## Driveshaft Replacement 40/50

### Models Affected

1995 Force 40/50  
Serial Number  
US 0E123524 thru 0E135075

**Figure 1. Driveshaft Date Code**

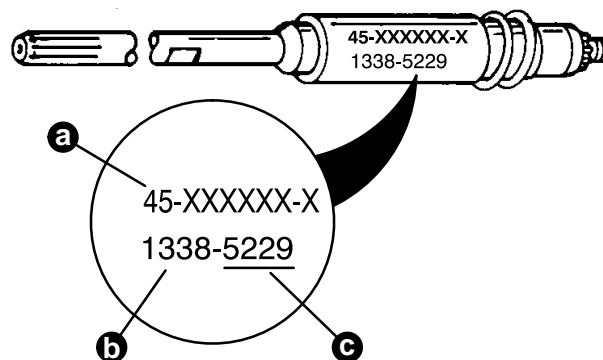
The outboards listed may have driveshafts with defective welds. Endurance testing has discovered a small possibility of voids in the weld that joins the stainless steel upper section to the carbon steel lower section of the driveshaft. Operation of the outboard may result in early driveshaft failure.

1. Remove gear housing and the driveshaft as outlined in the Outboard Service Manual.
2. Check the date code on the driveshaft per Figure 1.
3. Driveshaft **MUST BE** replaced if the date code is 5190 thru 5233.
4. Order Parts Kit p/n 809796A1 and driveshaft (if required) per this bulletin for reassembly.
5. Reassemble and install the gear housing as outlined in the Outboard Service Manual.
6. Fill the gear housing with Quicksilver gear lube, install the propeller, and check for proper operation of the outboard.

1. Check outboard and/or shipping carton within the affected serial number range for factory rework identification markings.
2. Outboards that have not been reworked at the factory within this serial number range must have the gear housing replaced. As an alternative, the driveshaft must be inspected and replaced if the date code is 5190 thru 5233 (Figure 1).
3. For Assistance:

**Figure 2. 40/50HP Rework Marking**

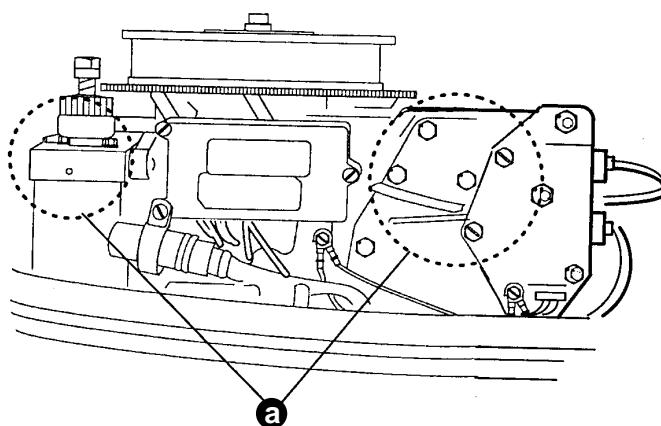
Outboards within the serial number range listed that have been reworked at the factory are identified by:

- A red or black letter "D" hand applied with a marker on the outboard serial number label of the shipping carton.
- A yellow dot or marking painted on the powerhead (Figure 2).
